RBW Comments on Red Hill Groundwater Modeling and Hydrogeologic Interpretations

2/15/18

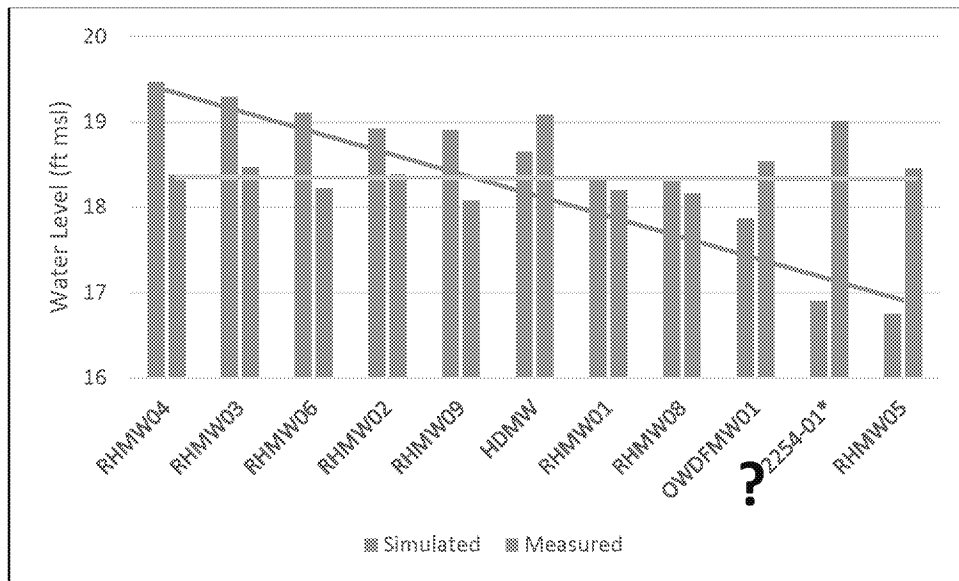
A re-evaluation of the groundwater gradient beneath the Red Hill Ridge after each of these events confirms that there is no perceptible groundwater gradient in a flow path going down the Red Hill Ridge. The bar graph on the following page compares the modeled groundwater elevations (blue bars) to those measured in 2017 (orange bars). An eyeball estimate trend line is drawn for data set. The values for the modeled groundwater elevations were derived by applying the modeled residuals in Slide 30 to the average of water level measurements during the July and November rounds of groundwater sampling. For the modeled capture zone shown on Slide 55 to be valid there should be reasonable agreement between the trend in the modeled and measured groundwater elevations. Clearly this is not the case, so after an investment of tens of millions of dollars the resulting model is no better than that of Rotzoll and El-Kadi.

The modeled groundwater elevations show a decreasing trend going from the upslope well, RHMW04 to the down slope wells, OWDFMW01, 2254-01, and RHMW05. The measured water levels show that there is no groundwater gradient trend going from RHMW04 to OWDFMW01. RHMW07 was excluded from this graph since it is a definite outlier and the drawdown during sampling shows poor connectivity to the larger aquifer. There is a question mark and an asterisk by the label for 2254-01, since the TOC reference point is uncertain and this is an actively pump shaft. Both conditions place in doubt how reflective the measured water level is in 2254-01 of the aquifer beneath the Red Hill Ridge.
